RE: Approval Notice, Conditional Use Permit 2024-004, Carriere/Syntech CF1, LLC Advanced Thermal Conversion,

Project Title: Conditional Use Permit 2024-004, Carriere/Syntech CF1, LLC Advanced Thermal Conversion

STAFF REPORT SUPPLEMENTAL (FOR CONTINUATION OF APRIL 16, 2025, PLANNING COMMISSION MEETING)

MITIGATED NEGATIVE DECLARATION: APPLICANT'S RESPONSE

C1

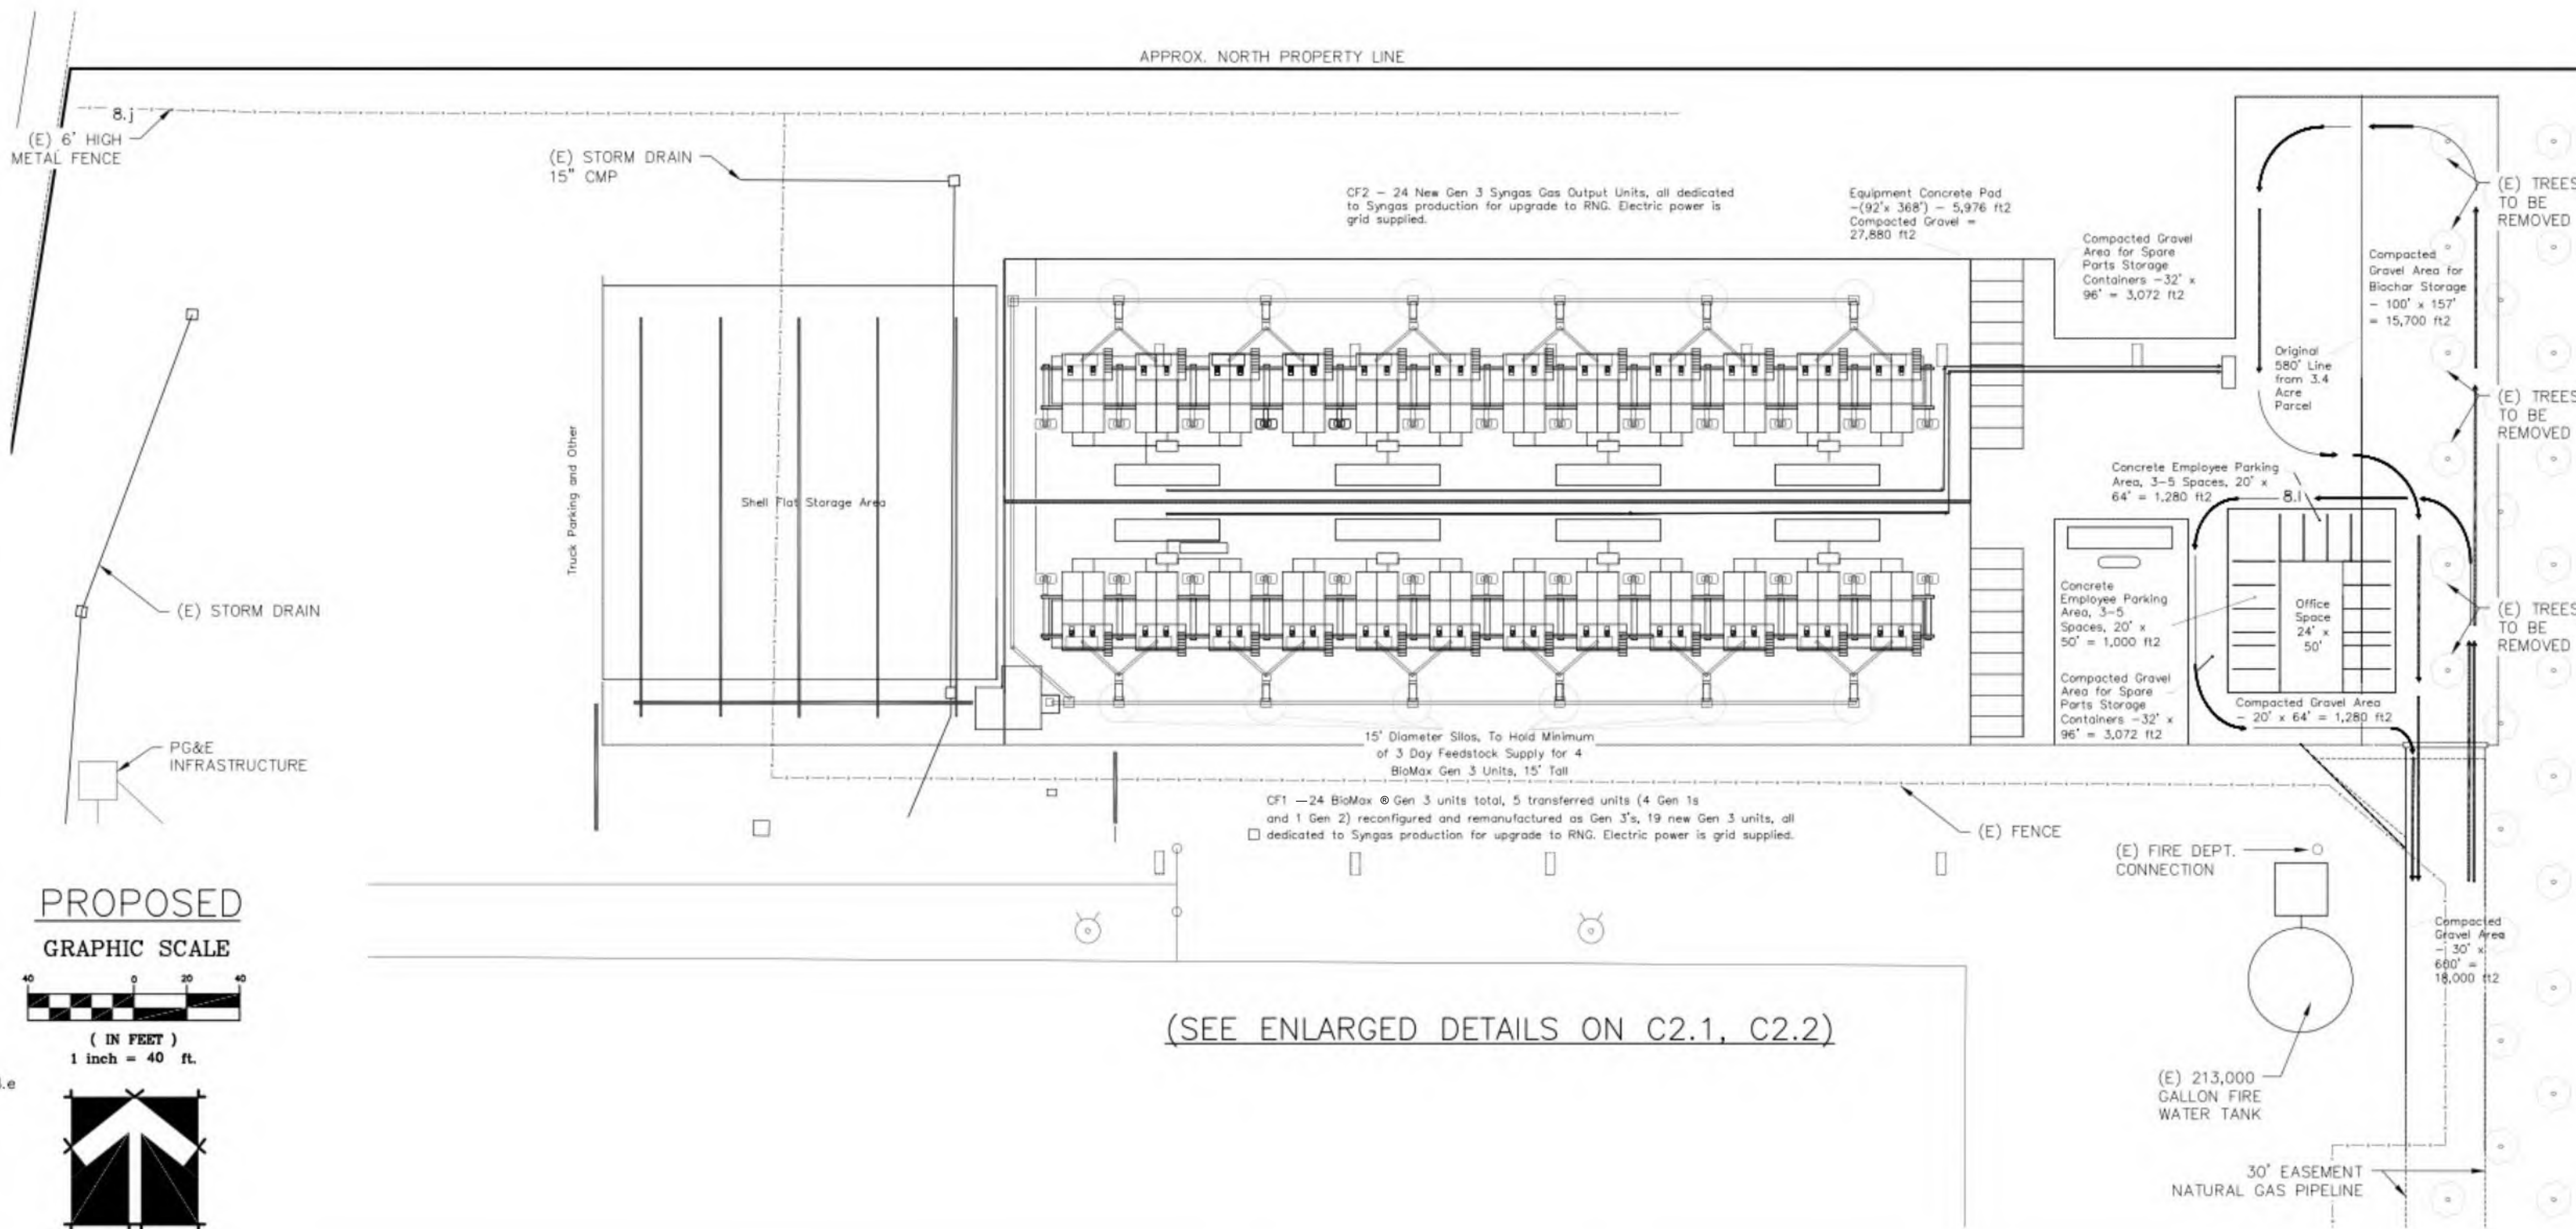
Comments for sheet C1 (page 57/60) off SR 45 and for sheet C1 (page 60/60) off SR 162. If the driveway access is from the SHS:

The applicant/operator shall provide Caltrans any requested information regarding driveway access to and from both sites. This information shall be in site plans showing proper dimension of all driveways as outlined in the California Highway Design Manual (HDM) with Auto Turn CAD templates, using the correct design vehicle, showing the design vehicle entering and exiting the site plans.
